The development SoWL, which proposes introducing a roundabout and clear span bridge, fails to meet **Arun Local Plan Policy W DM2 Flood Risk** criteria **b), d) and f) .**

The applicant does not satisfactorily demonstrate that introduction of the clear span bridge and roundabout to the north of the site will not increase flood risk elsewhere, or if potential mitigation or exceedance measures, such as creating temporary storage, areas may be needed.

Fig 1. Extract from the plan submitted with A/110/20/RES

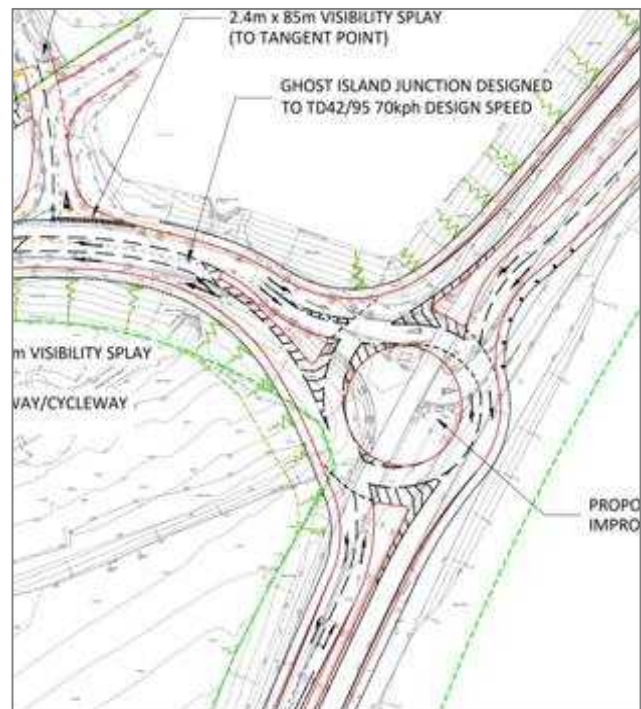
THE ROUNDABOUT: Fig 1 shows the new embankments (green squiggles) required to accommodate the new roundabout will result in loss of storage capacity to both the Black Ditch flood plain south of Water Lane, and the Surface Water Balancing Pond to the north. See Appendix A.

The Edenvale Young Associates (EVA): Roundabout Hydraulic Modelling covered a 2.6km length of the water course. The report ONLY concerns itself with the impact of the proposed roundabout, and reaches the conclusion that *"the proposed roundabout has negligible impact on catchment storage."* EVA did not use any local hydrological evidence (for example from photographs), to verify the accuracy of its model and thus its conclusions.

Fig 2. Extract from Bridge Contour Plan submitted with A/40/18/OUT

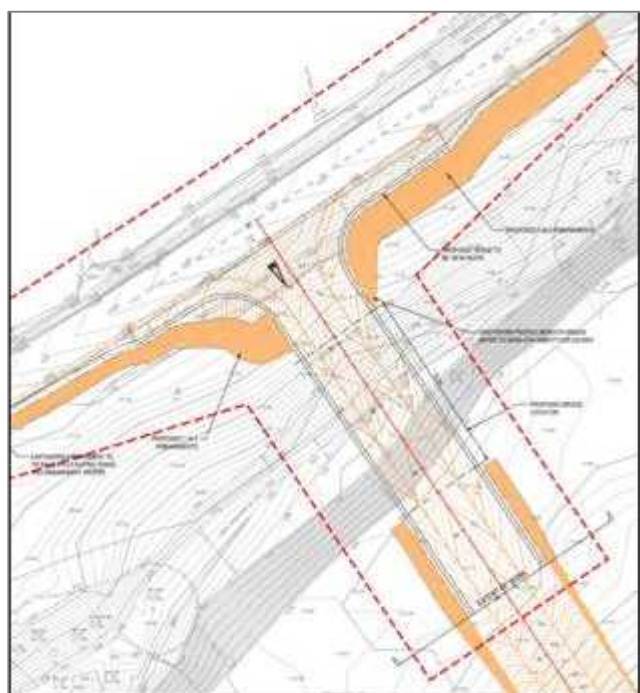
THE CLEAR SPAN BRIDGE: Fig 2 shows the proposed earth embankments WILL ALSO encroach into the Black Ditch flood plain south of Water Lane, further reducing it's capacity. The modelling done by EVA is used to demonstrate the bridge meets the 600mm clearance required by the EA. The Applicant seems to have achieved this.

The **Stantec Technical Note** point 6 considers the encroachment *"will only reduce flood plain storage by a small amount."*

It is not clear however, what the cumulative impact of the loss of flood storage capacity is, what a "small" reduction to flood plain storage equates to, or if any compensation measures or mitigation may be required, regardless of the type of bridge design.

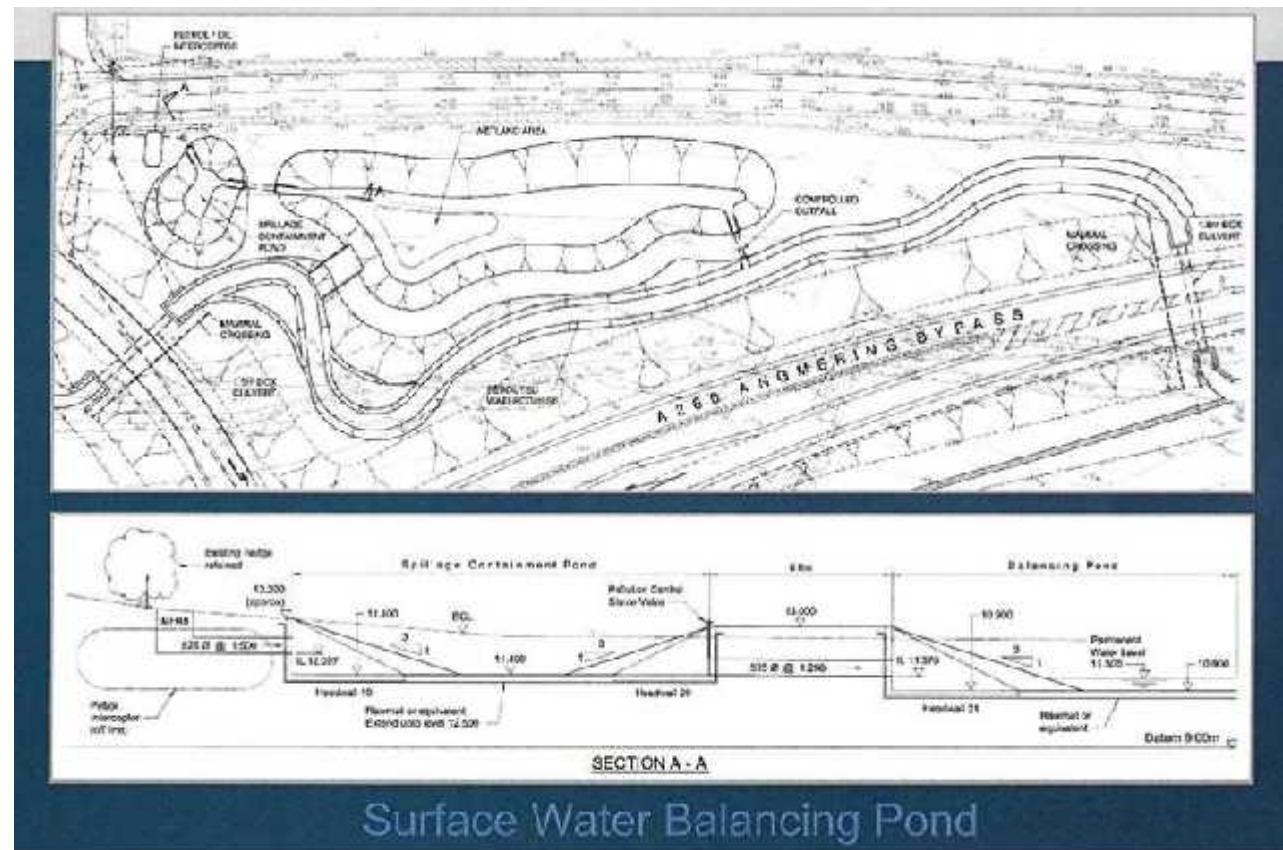
The location of the Surface Water Balancing Pond shown in the image on the left is from a presentation by Peter Brett Associates (PBA). See Appendix B. It was constructed during the building of the A280 by-pass, which required the Black Ditch to be re-routed via the culvert introduced under this part of Water Lane to the catchment basin north of the SoWL site.

Photos taken 14 Feb 2014 at 16:07 and 16:08 at the entrance to the Oval Raceway show flooding from the land north of Water Lane and the upper Black Ditch . On the far right hand side of the 2nd photo (taken a few minutes later) you can just make out the Pond is level with the road. With nowhere else to go water continues to collect as can be measured by the road markings.

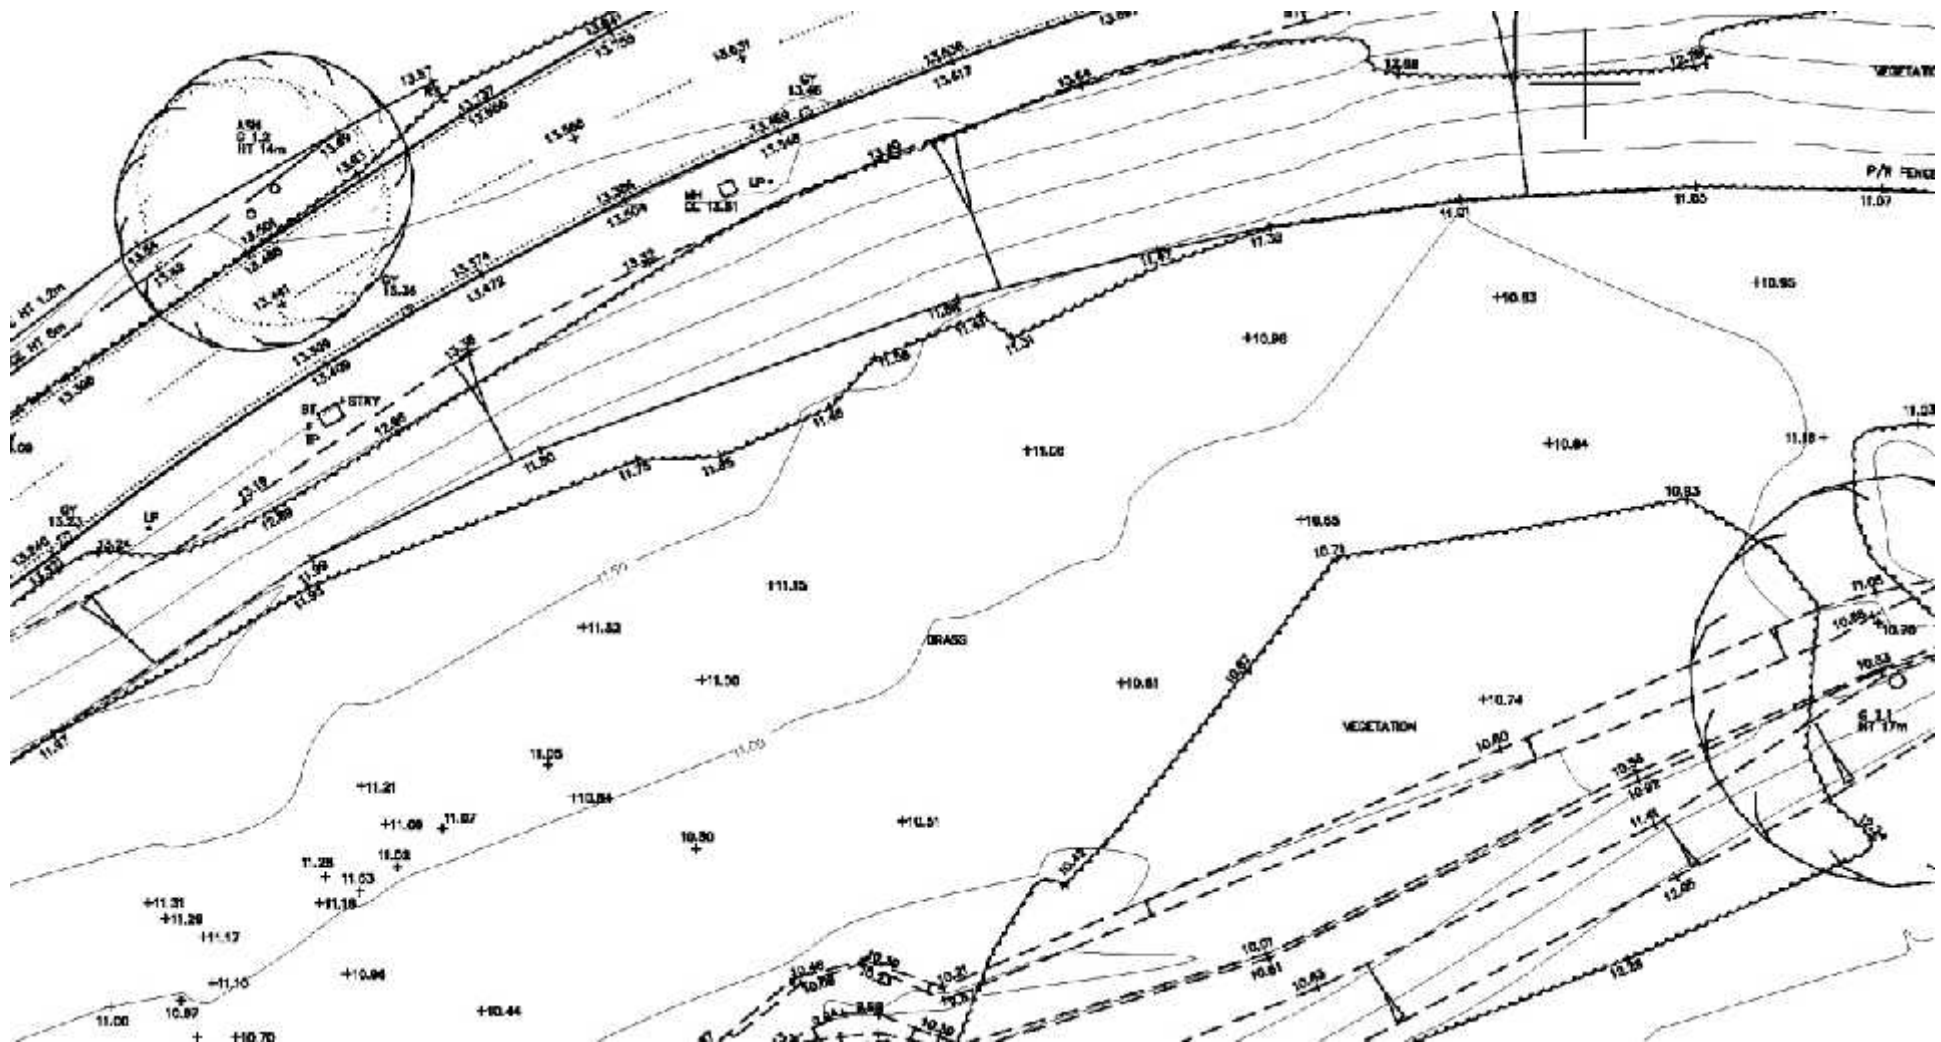
Comparing the images left to actual photographic evidence (below) suggests normal winter water levels reach to the bottom of the bank below the fence line at the north east corner of the site, somewhere between the 11m and 11.5m AOD marks.

The contour of the water line and topography of the site suggests the water level was slightly higher than the 11m AOD, which dips away sharply from the bank at this point. This can be seen more clearly on the next page.
